IN THE MATTER OF A NOTIFIED RESOURCE CONSENT APPLICATION FOR
SUBDIVISION TO CREATE 11 LOTS (8 RURAL LIFESYLE
LOTS, 2 BALANCE LOTS, AND A LOT TO BE
AMALGAMATED AS A BOUNDARY ADJUSTMENT) AT
MANGAKURI ROAD (RM230016)

SUMMARY STATEMENT OF SIMON GABRIELLE

Mangakuri Station Subdivision

Rebuttal to the submission from Michael Smith

Figure 1 – Graph of Geo specific rainfall intensity data for the site. Data Source <https://hirds.niwa.co.nz> downloaded on the 14th Sept 2022

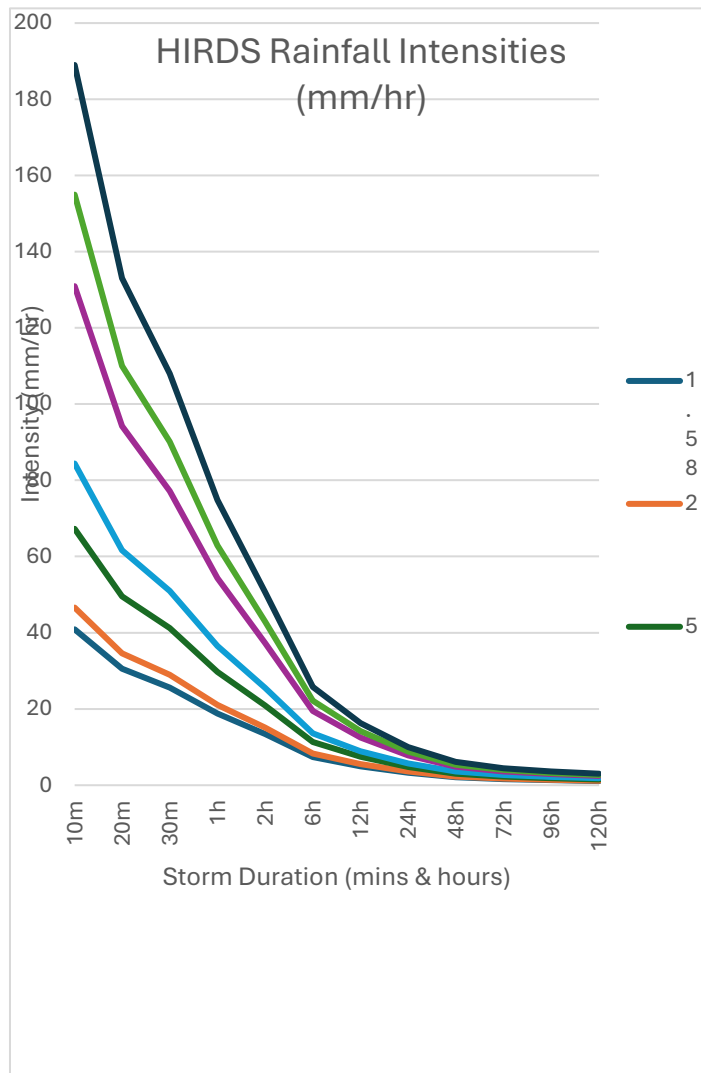
#14 - 15

The graph in figure 1 illustrates the rainfall intensity data used in the analysis to date, noting the worst-case RCP (representative concentration pathways) of 8.5 has been adopted. The graph illustrates that the shorter storm duration has much higher rainfall intensities. The total volume of rainfall may be greater in longer duration events, but in the context of the Mangakuri development, the downstream environment assessed considers the existing channels capacity (breach risk) and the discharge environment. Effectively, the rate of discharge from the development to the downstream environment is what the preliminary design has sought to mitigate.

The downstream environment be more adversely affected by short duration events which result in increased run-off rates compared to the longer duration events, noting the events cited by Mr Smith are all 9 hours or more in duration. Furthermore, throughout various recognised methods for analysing stormwater flows, the size of the

catchment is always used to determine the time of concentration to apply to determine the peak run-off generated.

As a simplistic example, for a catchment of 6.59 Ha (same as catchment B), with a run-off coefficient of 0.4, a 100-year, 30-minute event has an intensity of 90.1 mm/hour, which equates to a total peak run-off rate of **660** litres per second.

By comparison, a 250-year 24-hour event (similar to that reported by Mr Smith) has an average event intensity of 10mm/hour, which only equates to a total peak run-off rate of **73** litres per second. So, although the total event volumes may be much more, the potential for the existing stormwater channels to be breached, or scouring of the discharge environment is lower than the events analysed in my report.
